## ADDENDUM 2

### ROADWAY IMPROVEMENTS FOR COUNTY ROAD H & SR109 & TRAFFIC SIGNAL INSTALLATION

**RE:** Blank Plan Sheets, Bore Logs, Questions and Answers, Updated Unit Price Bid Sheet, Estimate

### Exploration Plan

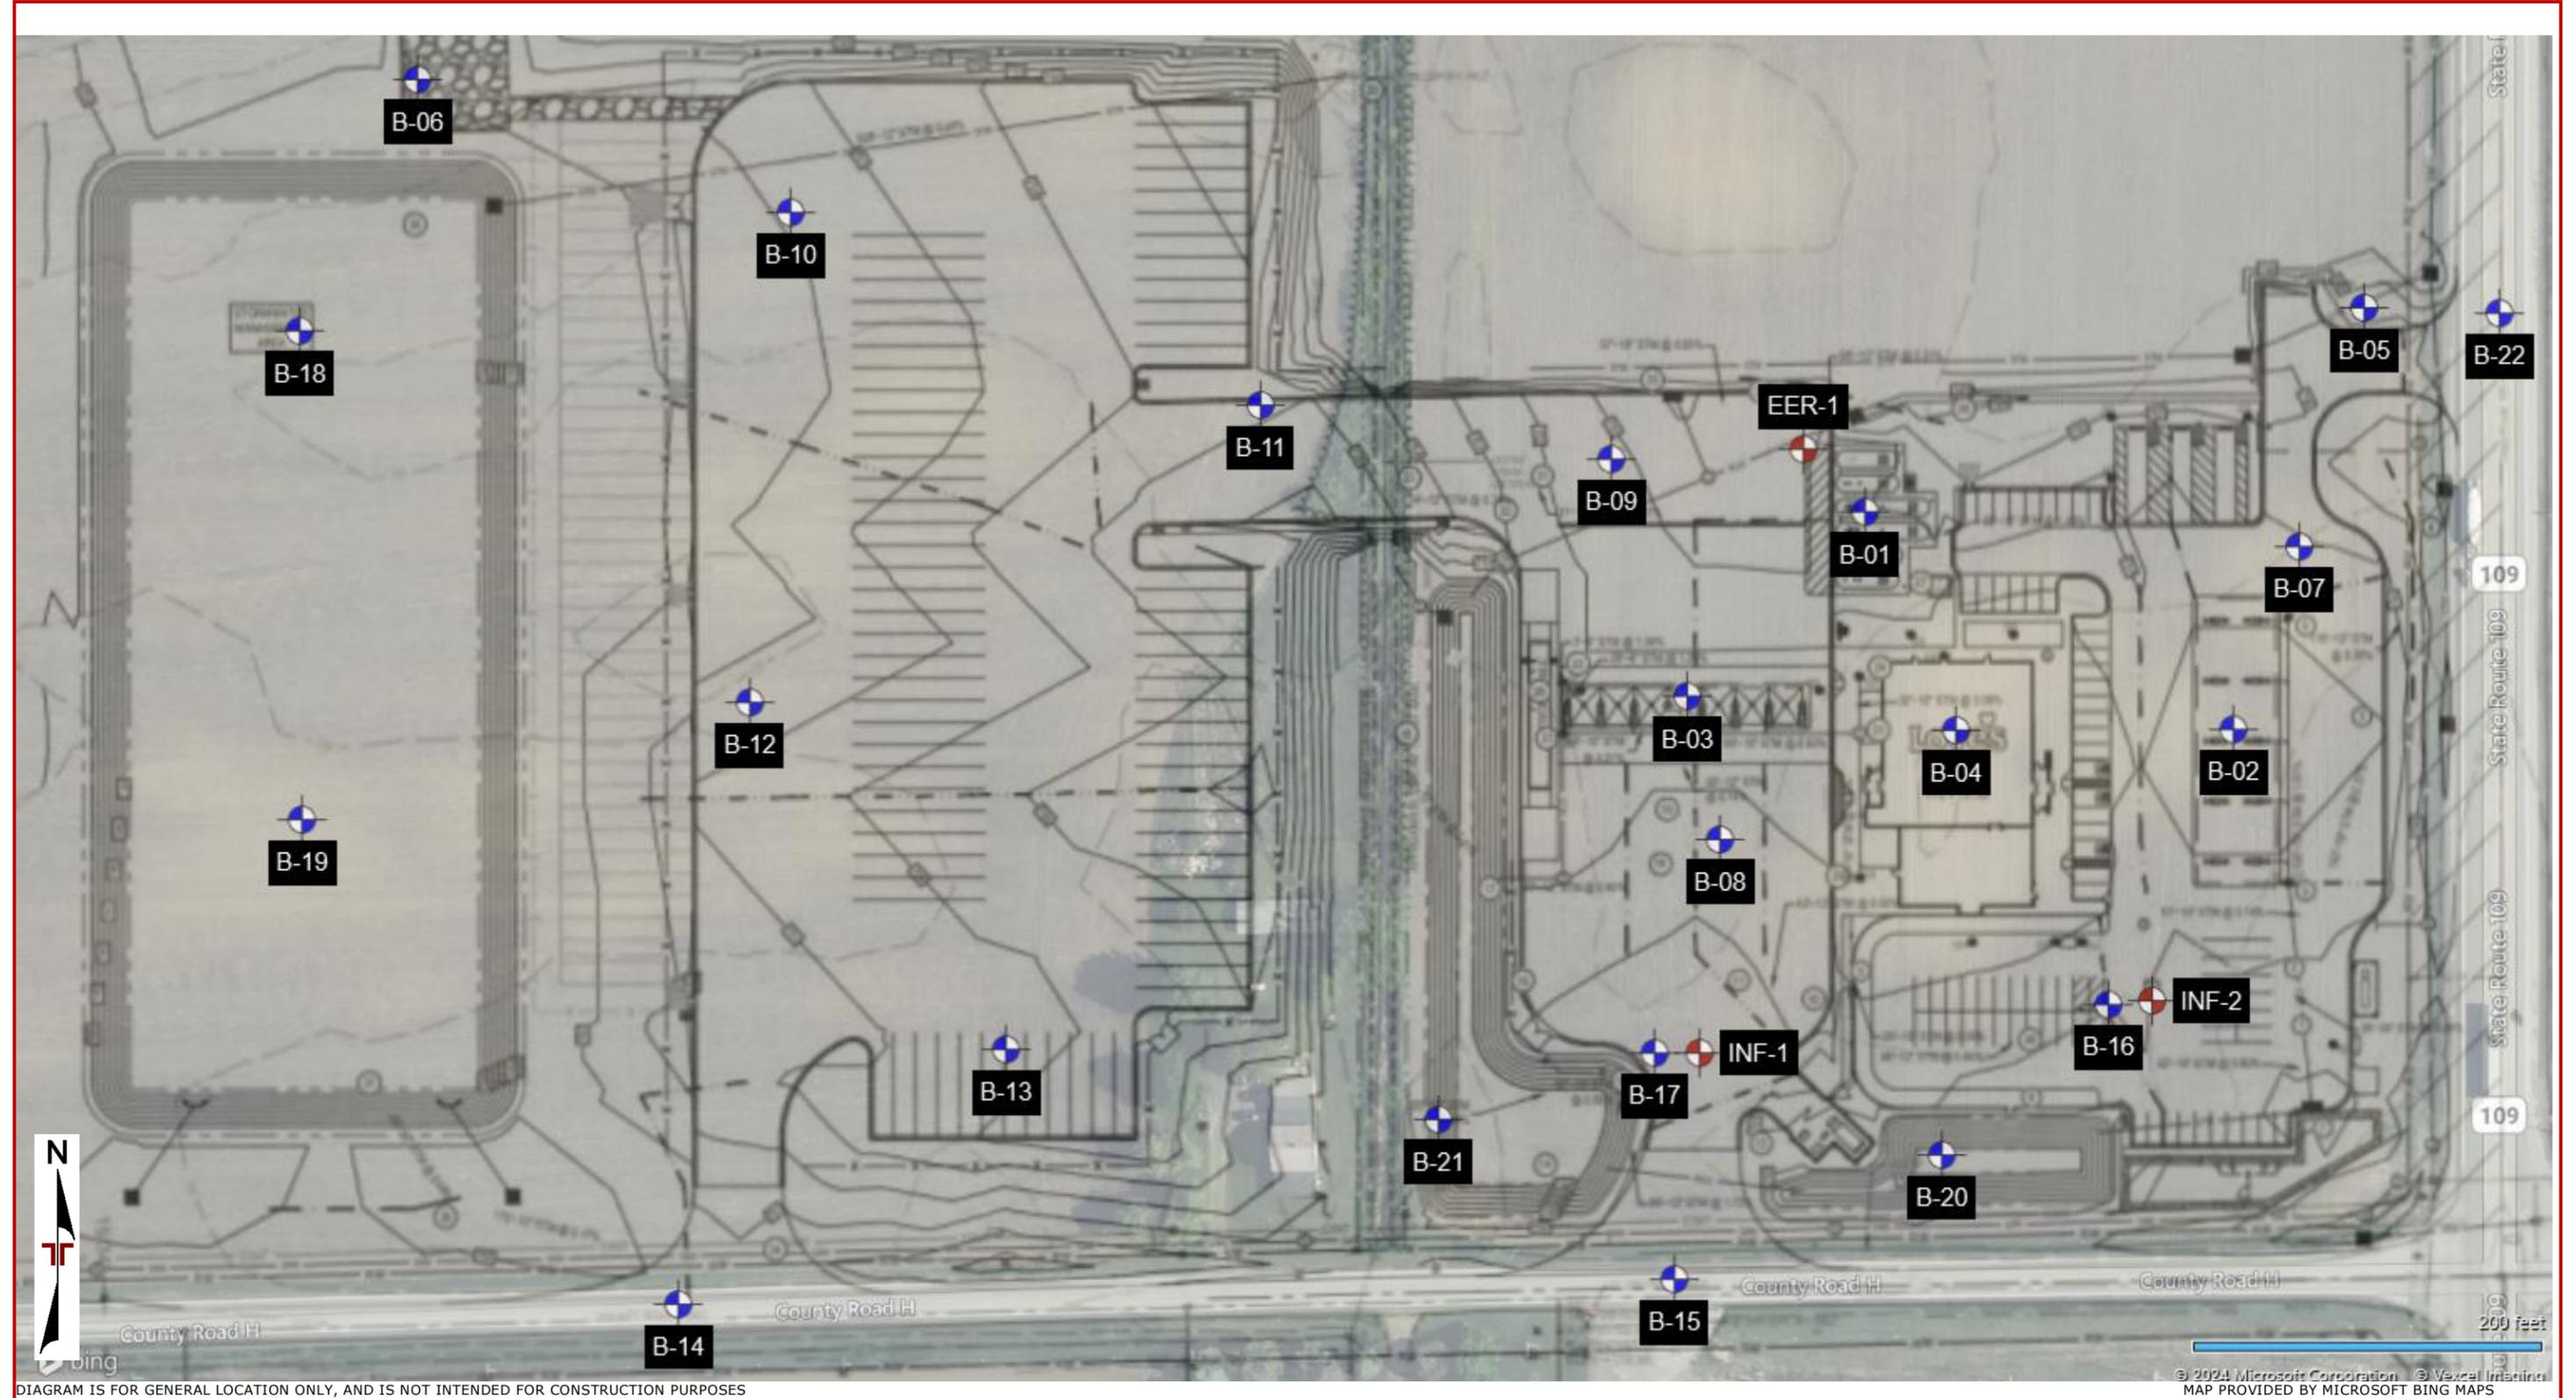
1. Plan Sheets R5, R7, R8, R17, R18, R19, R20, R31 and R33 are intentionally blank.
2. Two borings are available on CR H and one boring was taken on SR 109; see attached information from the Geotech report. Note that the borings were completed in July of 2024. ODOT completed a project after the borings were taken that involved milling off 3" and placing 3" of Asphalt Concrete Intermediate Course, 88-22 and 3" of Asphalt Concrete Surface Course, 88-22.
3. Question: There are quantities for 12" B and C pipe, and a headwall in the SR109 Improvements. The drawings do not show anywhere near the bid quantities and also appear to indicate that the storm is to be installed by the site contractor. Can this be clarified and a better storm sewer plan be provided?
